MEMORANDUM

SUBJECT: East Grand Avenue Overlay District Zoning Study – Public Testimony and Revised Proposed Amendments

TO: Planning Commission

FROM: Comprehensive and Neighborhood Planning Committee

IMAGE B- (2x) 2-bed & (2x) 1-bed units

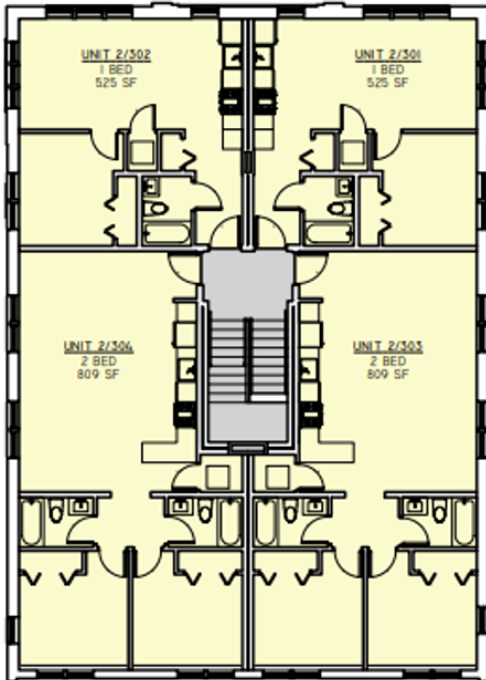
Image B on the left below shows the 3rd floor of the building without stepbacks includes two 2-bed units and two 1-bed units . **Image C** on the right shows the stepbacks as proposed would result in the loss of >50% of the built square footage and two 2-bed units. **Under these conditions, no project would be built.**

In a development with the stepbacks pictured on the right:

- The cost of land, design, utilities, fire protection and facade would stay the same
- The cost of framing would increase with added complexity
- The rent generated by the project, which is required by lenders and investors, would decline due to the loss of multiple units

1. **Sustain Saint Paul's highest-priority proposed change, Side & Rear Yards:** Stepbacks should only apply to front yards, or corner-side yards on projects with >200' of street frontage (e.g. 150' typical lot depth + >50' Grand Ave frontage). Rear yards should not have any step back requirement.

3. **Change the Stepback Threshold:** Increase the current 30' height threshold triggering a 10' stepback to a 40' threshold.

** 800 Grand Ave, 3 stories (0 setback from both)*

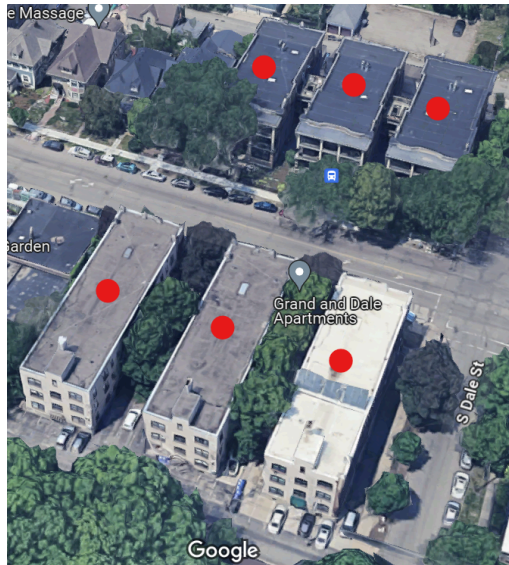
Appendix: Examples of existing Grand Avenue buildings east of Virginia that would be prohibited to build under the current proposed overlay district

excerpt from page 4.

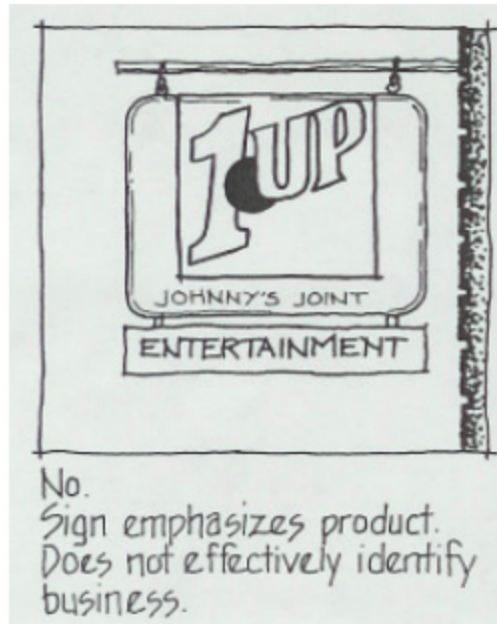
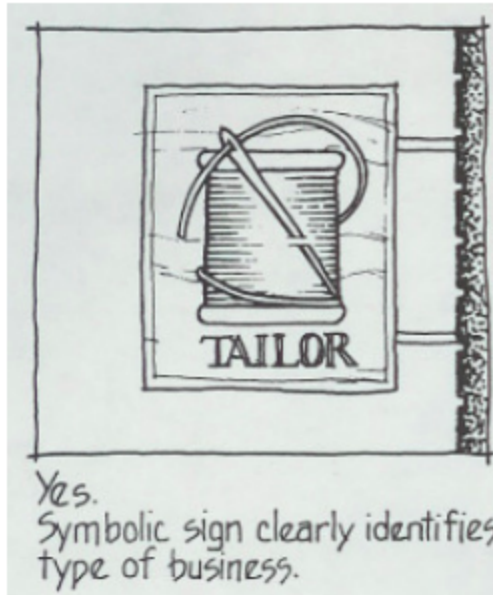
Focus on the Business name instead of a product placement.
